KMR.CDD.RaQ.1920.01

KMR.CDD.RaQ.1920.01
No. CDC 936 of 1920,
Revenue Department,
City Deputy Collector's Office,
Karachi. 13th July 1920.

AMENDED
PLAN SHOWING PROPOSED BUILDING
ON PORTION OF PLOT N^o 107 E.G.
RAMSWAMY QUARTER
SCALE 4 FEET TO 1" INCH

I beg to inform you that I intend building The Proposed building
to be built on portion of plot No. 107
Survey Sheet No. E. 6 situate in Ram Swami quarters
Street, Jewan Quarter.

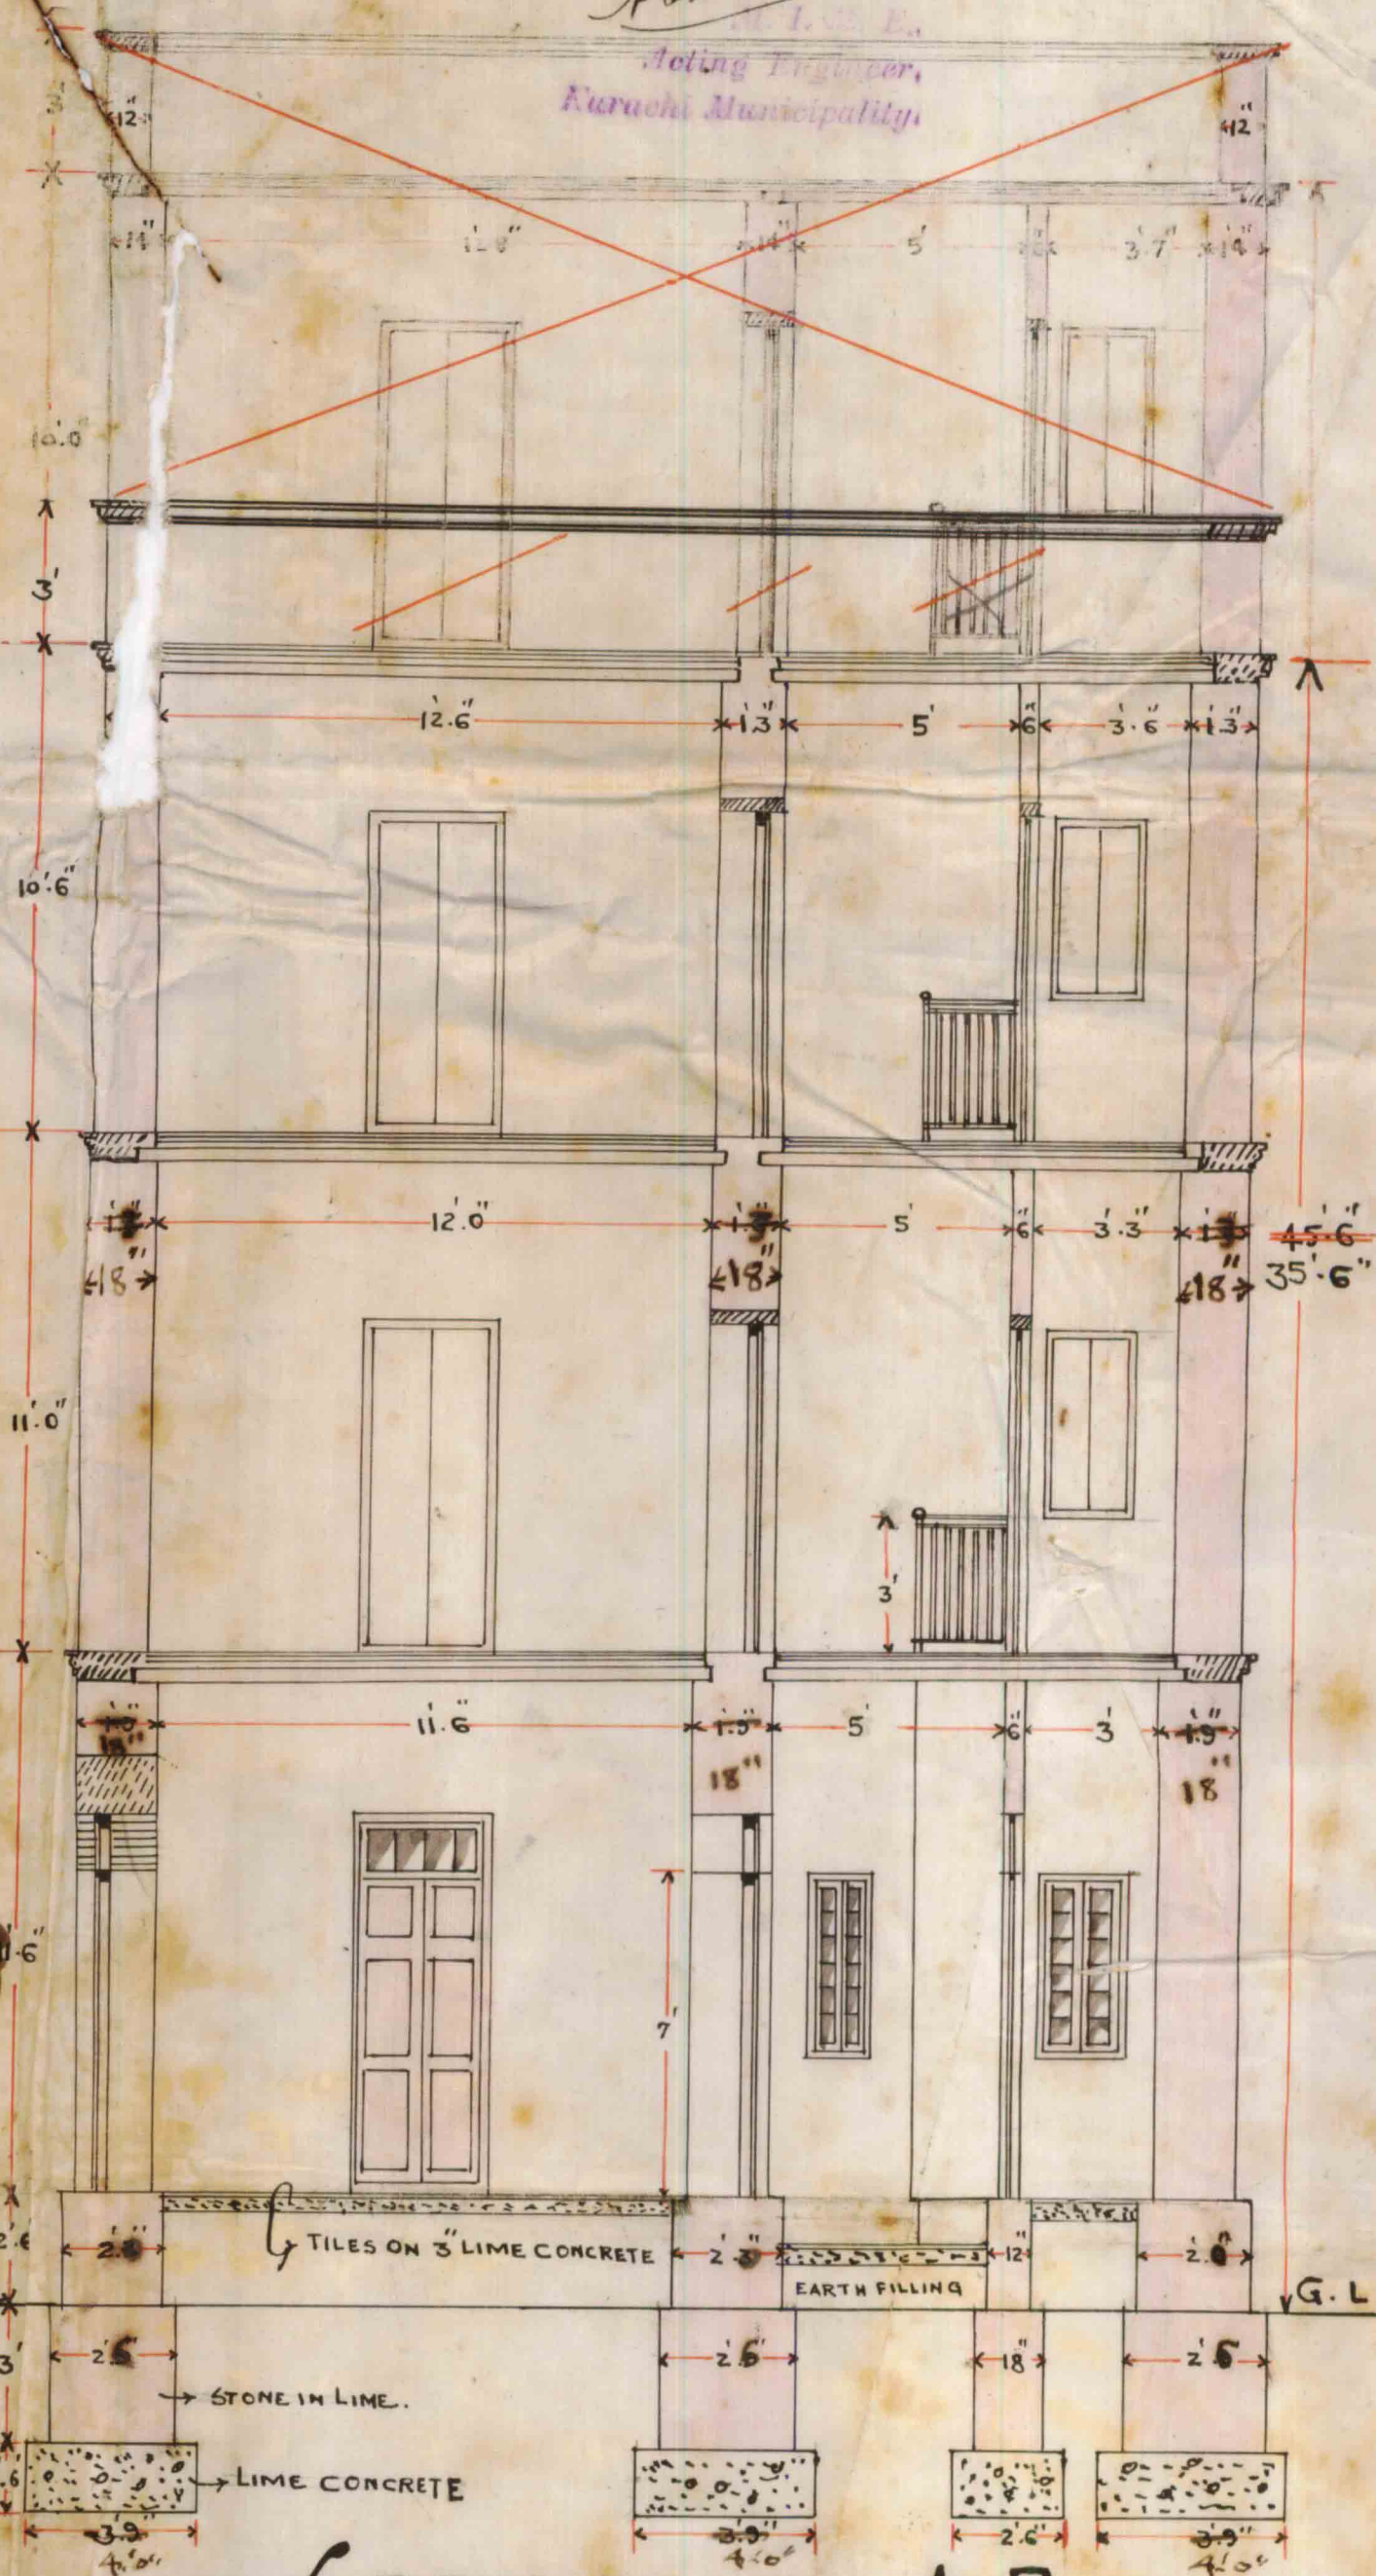
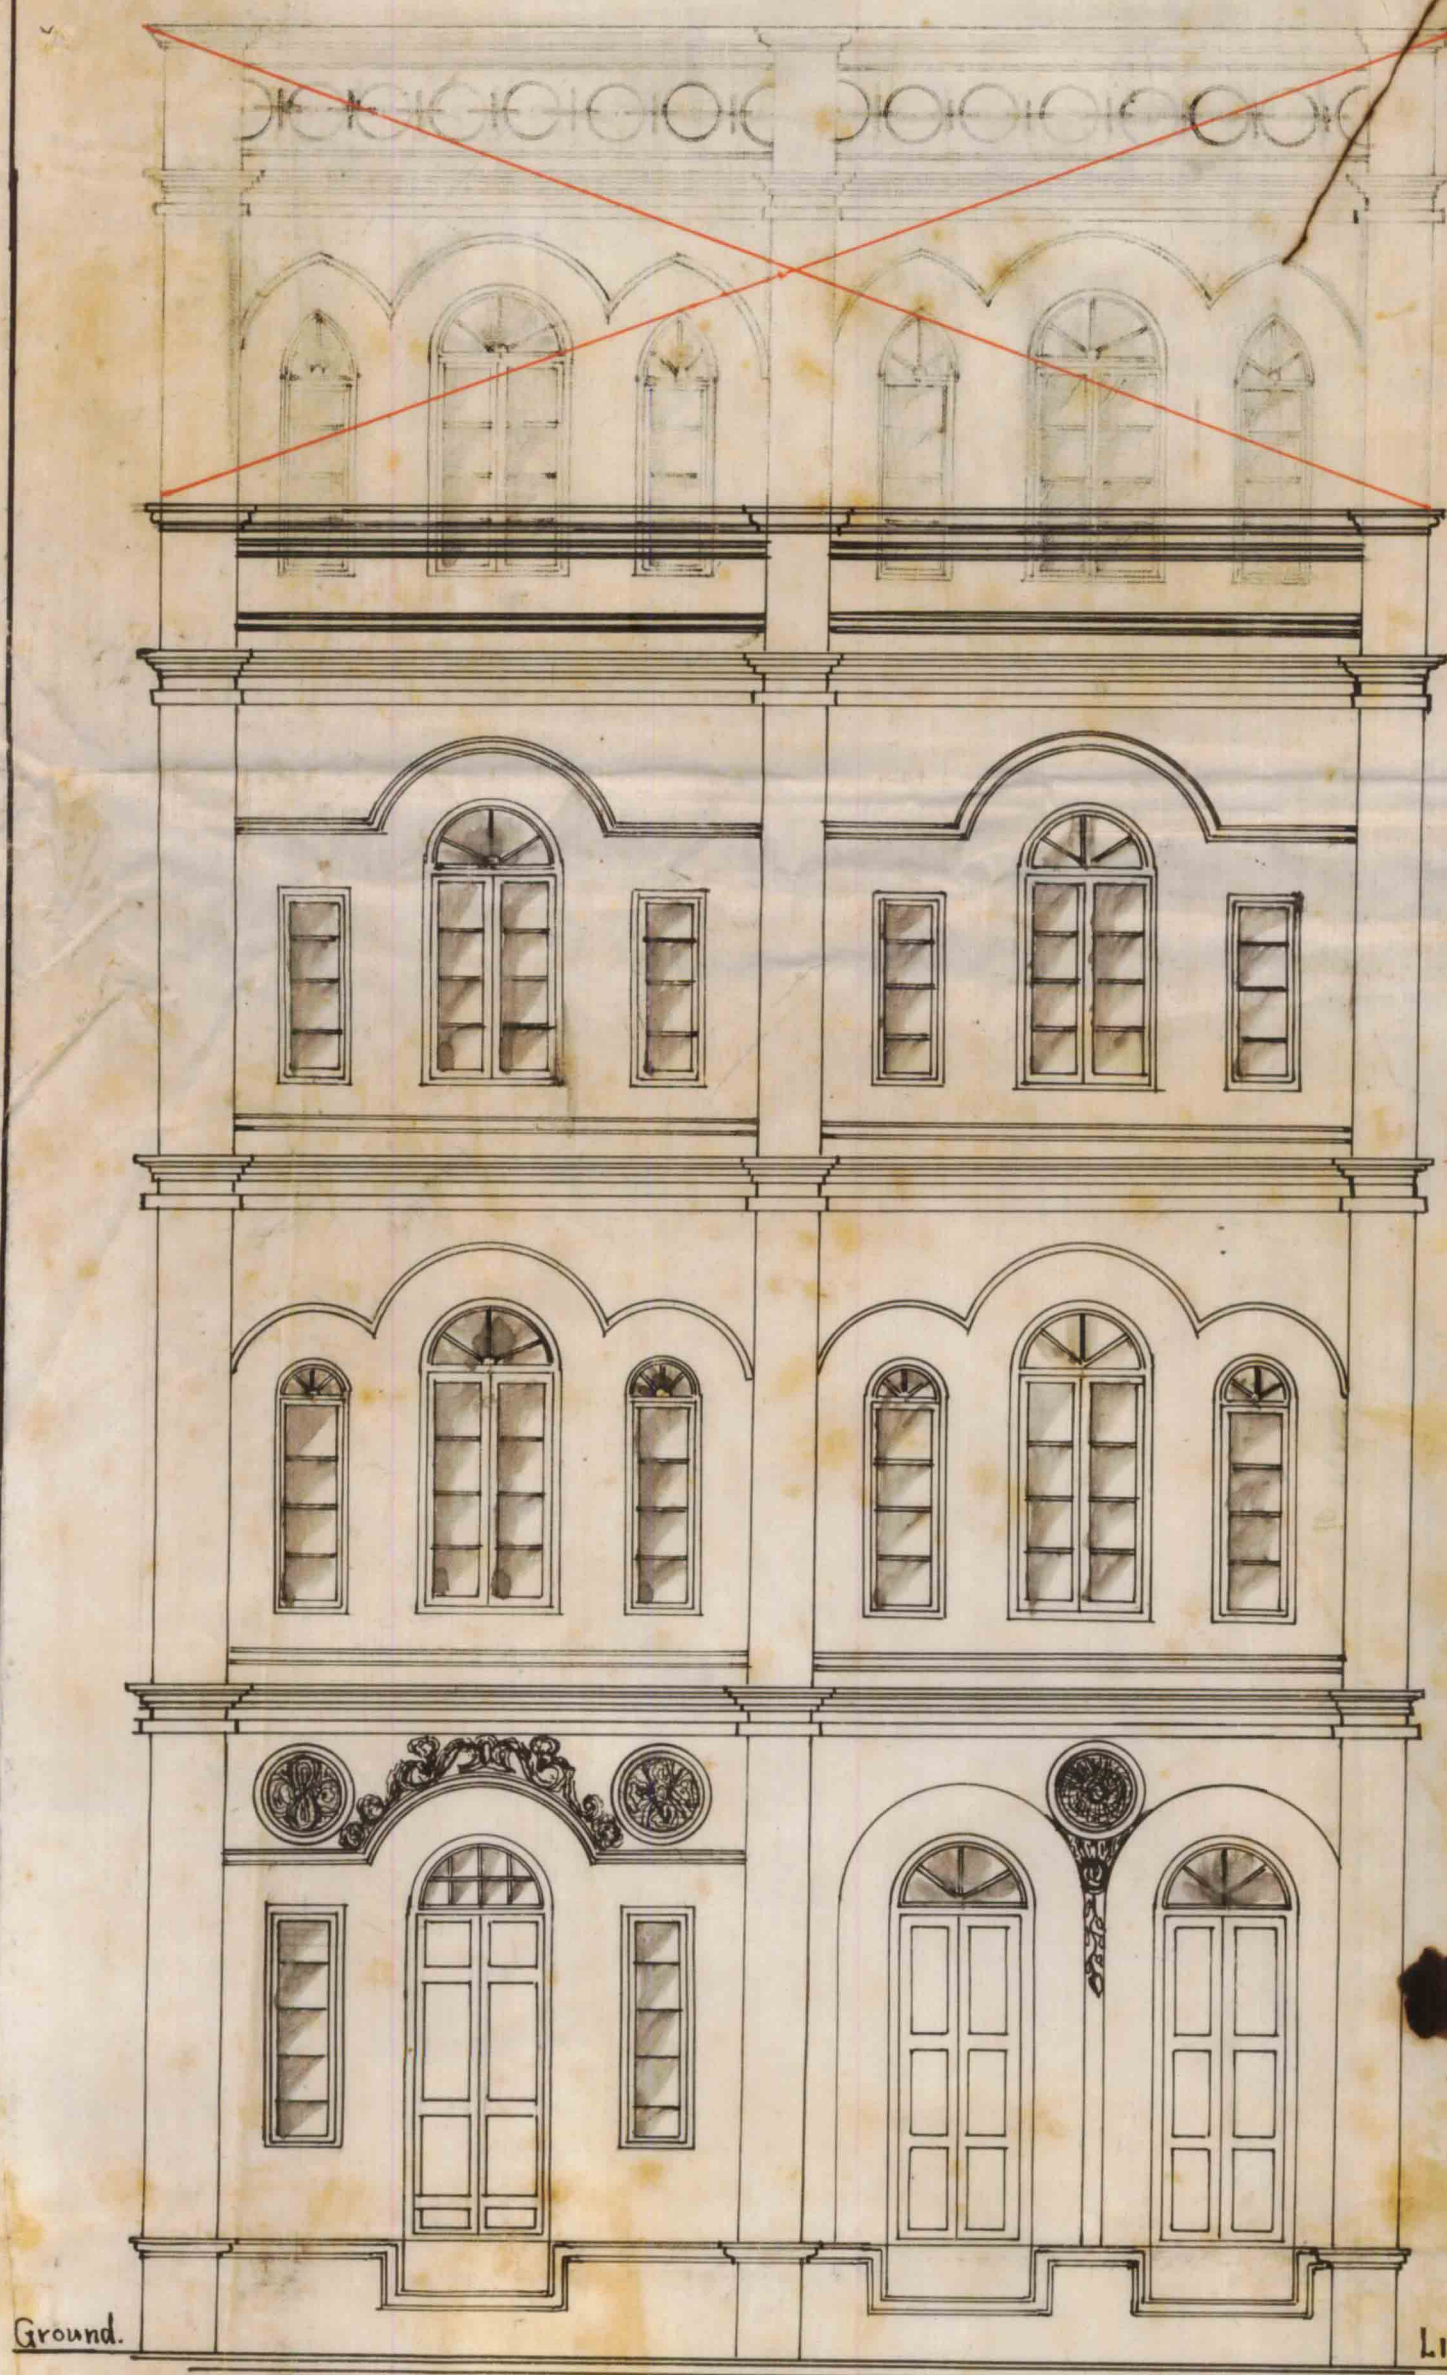
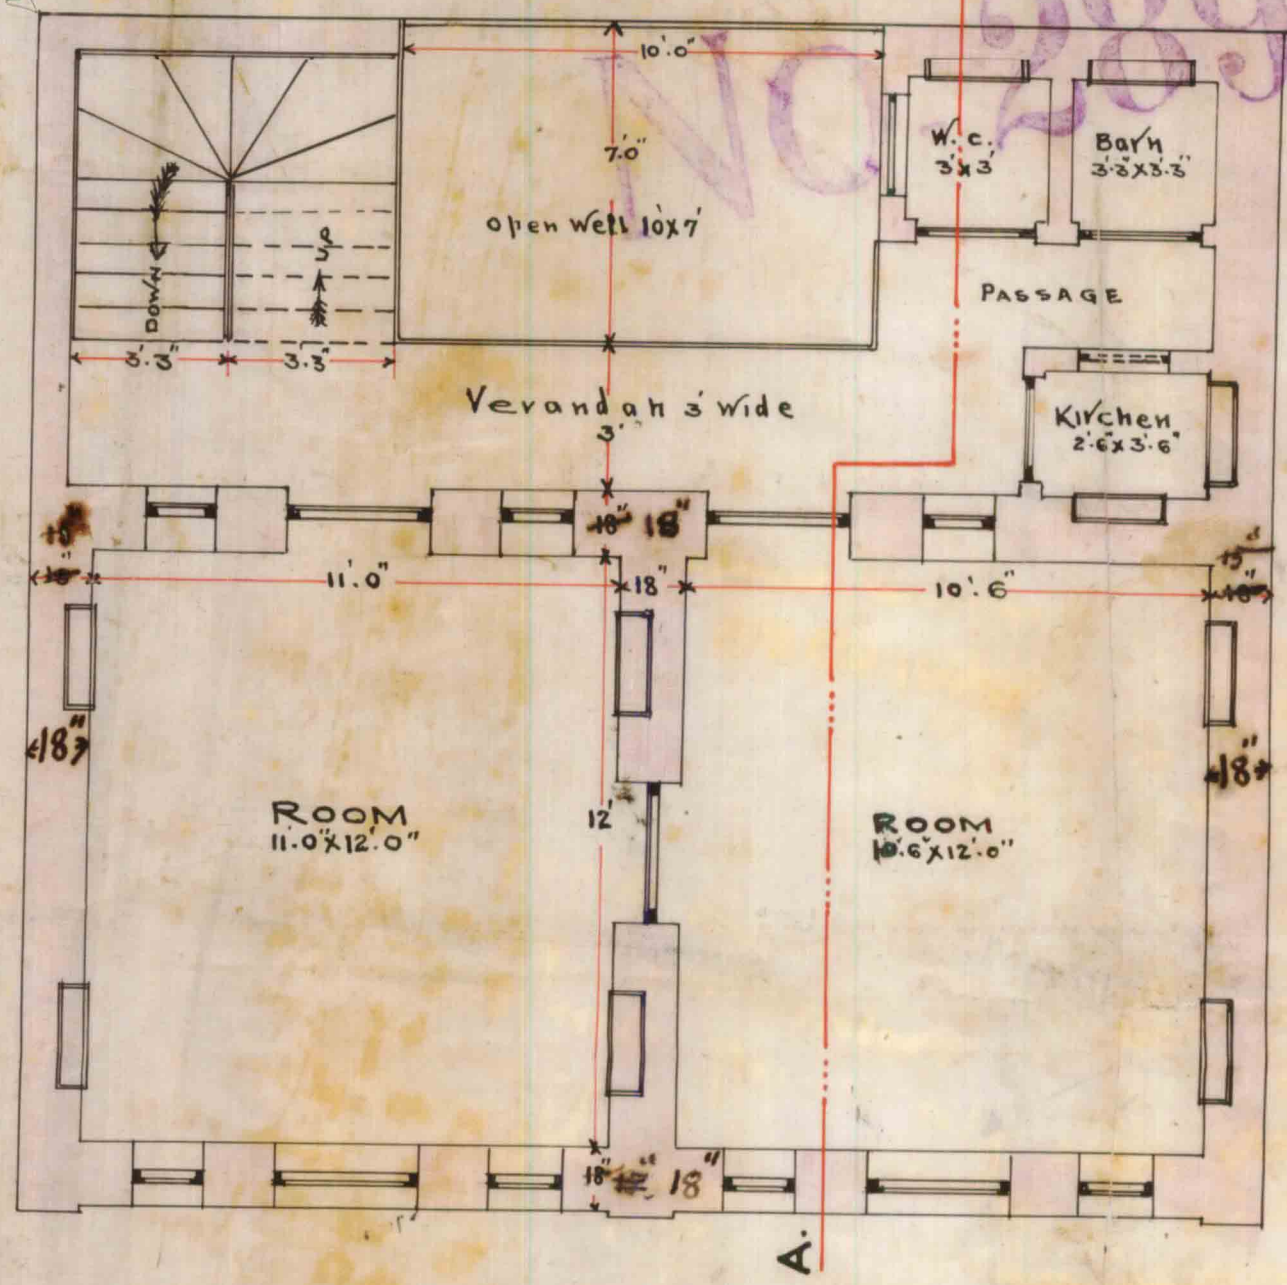
With reference to his application dated 30th ultimo, with a plan for the proposed building on portion of plot No:107. Sheet E-6 Ramswami quarter Mr Jeram Virji is informed that permission to build a four storied building on a small portion of the plot will not be permitted. One floor must be deleted.

SirWith reference to the Rep Report thatthickness of walls must be kept 21", 18", 18" & 15"instead of 21", 18", 15" & 14" & width of foundationincreased to 10'0".

Remarks Sir, With reference to his letter to report
that the plot should be subdivided before
it can be approved. That it is not advisable
to allow the building to be erected on such
a small plot. Open space should be reserved

Permission to build a four storied building
on a small portion of the plot will not
be permitted. 1.21/5/20

With reference to his application dated the 2nd November 1920, requesting permission to build on a portion of plot No. 107 (Sheet E-6) Ramswamy Quarter, in accordance with plan No. 274 approved by the Engineer, Karachi Municipality, Seth Jeram Virji is informed that the above plans can not be sanctioned until an access is provided to the open yard.

With reference to this I beg
to report one floor has been
deleted. There is no objection
in issuing permission.

Regarding your no L.S. 2929 Dtd. 28th May, I herewith enclose the plan of the proposed building on plot no. 107 Sheet E.6. *Ran...* *quarrel*, altered as suggested by you. *...ing an early ...*

Submitted with report, the plan has been amended in the light of C.D.C. remarks. There will be now no objections to issue plan after hearing from the C.D.C.
